Our Case Number: ABP-321937-25

Re: This proposed development is for flood defences at key locations along the Carrickmines and Shanganagh rivers including new walls/raised existing walls, culverts, localised screens upgrades and localised works in the river. An Environmental Impact Assessment Report (EIAR) is submitted with application
This proposed Flood Relief Scheme for the Carrickmines-Shanganagh Rivers at sites in the townlands of Woodside, Kilgobbin, Carrickmines, Brennanstown, Shankill, Loughlinstown, Shanganagh and Hackettsland

To: An Bord Pleanála
Ref: 391937
Carrickmines-Shanganagh River Flood Relief Scheme

This Submission relates mainly to Flood Cell 5 and the southern section of the Bayview Estate Killiney, which is bounded by the Shanganagh River.

Shangawagh River and proposed Flood Defences N
(Sector 5)

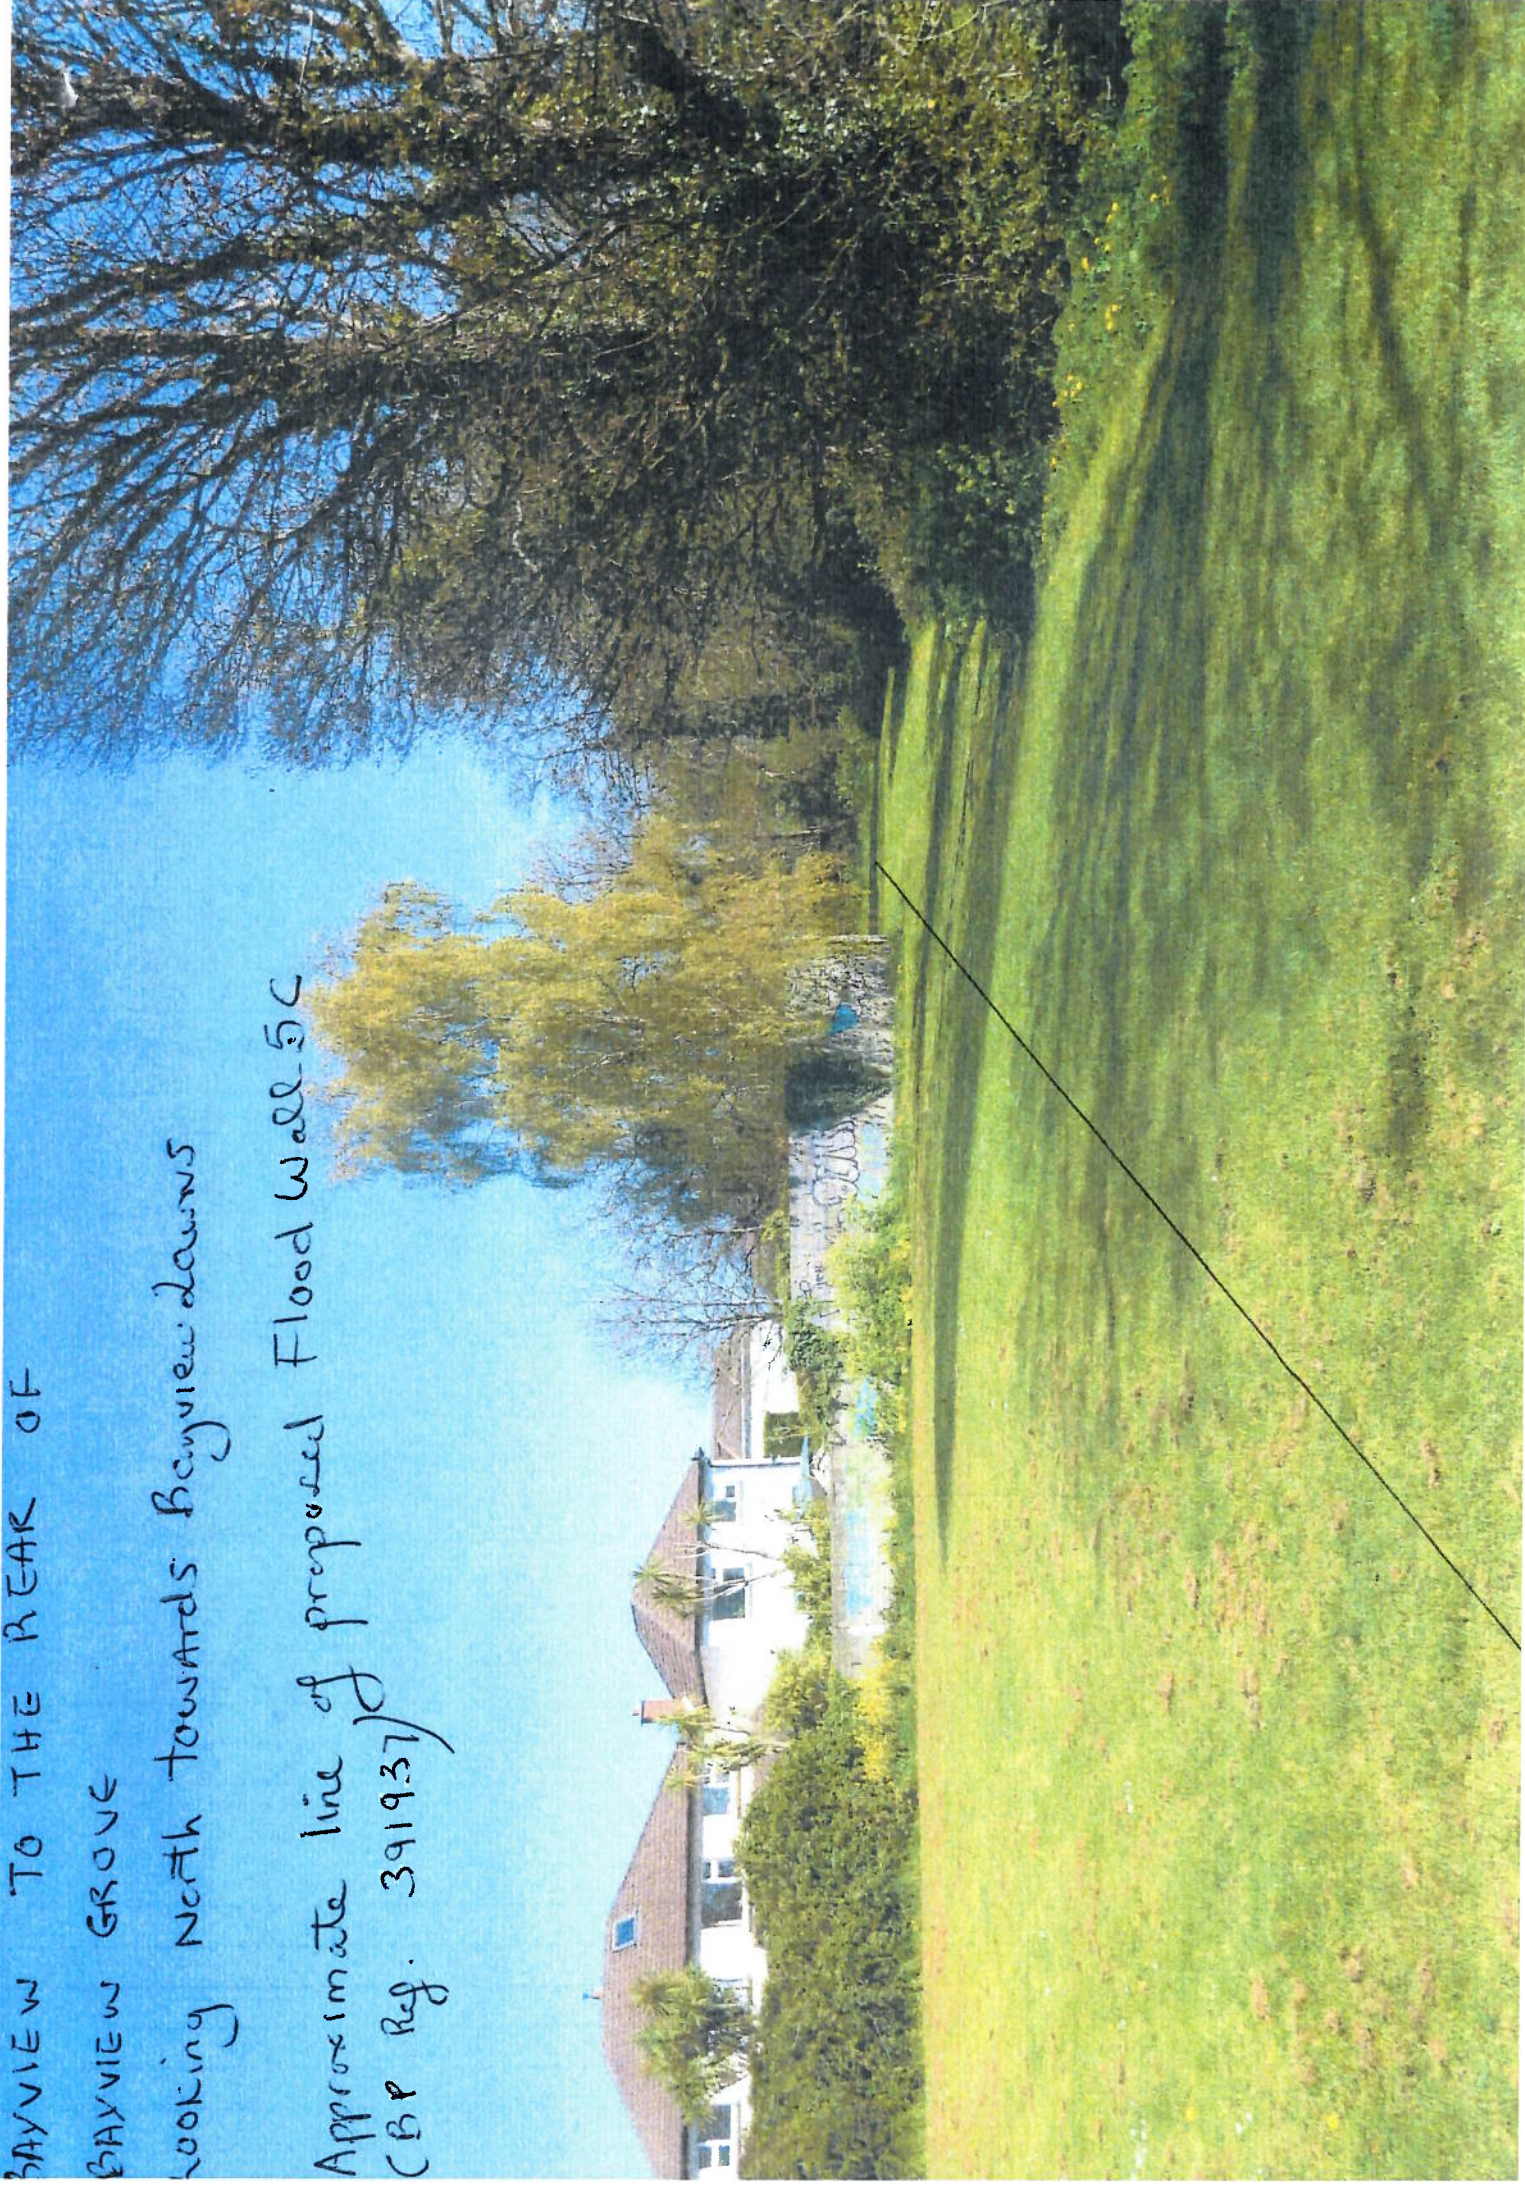
Fallen Tree across river channel after Storm Eoghan 2025 (at Bayview Defence 5C Proposed flood wall site) April 2025: tree still lying across the channel.
Between Bayview Glen and Bayview Lawns

Approximate line of proposed Flood Wall 5C

Looking Northwards.
Approximate line of
Flood Wall (BP 391397)
← Defence 5C

Dublin Array Windfarm proposed Cable Route and the proposed Flood Walls.

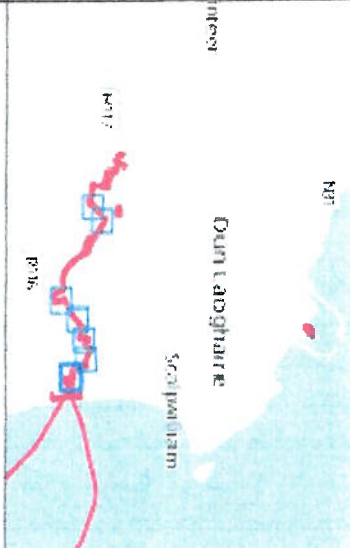
---: Approximate Route of Dublin Array windfarm double cable.

---: Approximate line of incoming windfarm cables (shaded in cliffs)
